UNITED STATES PATENT AND TRADEMARK OFFICE

APPLICATION NO.	FILING DATE	FIRST NAMED INVENTOR	ATTORNEY DOCKET NO.	CONFIRMATION NO.
09/910,872	07/24/2001	Yasumichi Kuwayama	Q65548	4044

Office Action Summary

Fig 1

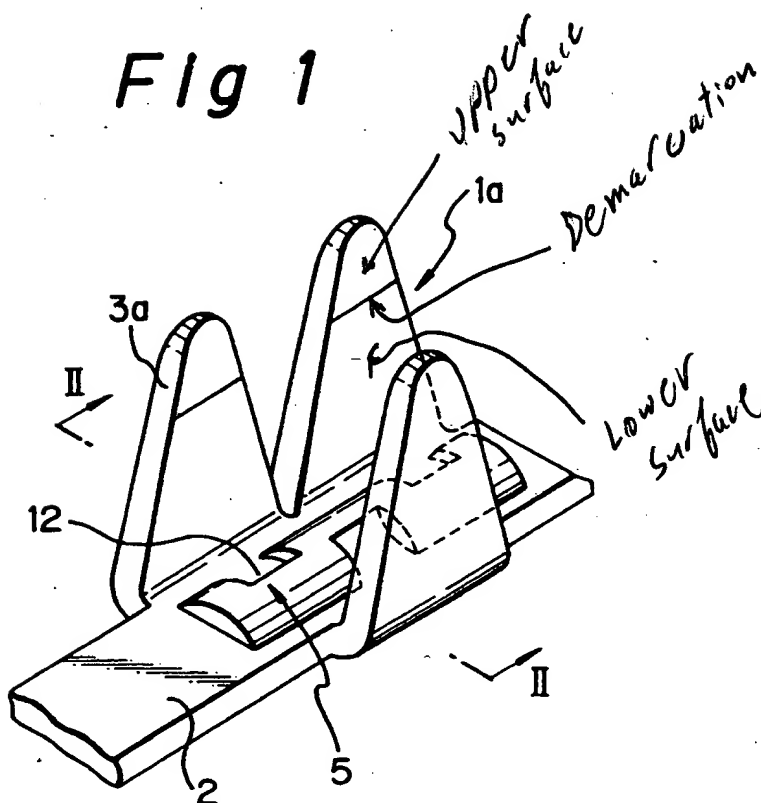
5. Regarding claim 2, Chen does not show the outer surface of the piercing portion as being tapered. Murakami shows both the internal and external distal portions of the piercing portions being tapered with respect to the root portions (see attachment). At the time of the invention, it would have been obvious to taper the inner surface, the outer surface, or both, as taught in Murakami. The suggestion or motivation for doing so would have been to facilitate piercing of the attached flexible circuit as taught in Murakami and Chen. The decision as to whether to taper only the inner surface, only the outer surface, or both would have been an arbitrary engineering design choice (as stated by Chen, col. 4, lines 1-6), given that all the configurations are well known in the art.

1. Applicant's arguments with respect to claims 1-10 have been considered but are moot in view of the new ground(s) of rejection. However, regarding Murakami, the examiner disagrees with applicant's assertion that the Murakami piercing portions are tapered on the exterior surface

only. Murakami clearly shows the internal surface tapered section demarcation line in figure 1 and the demarcation point is also discernible in figure 2 (see attachment).
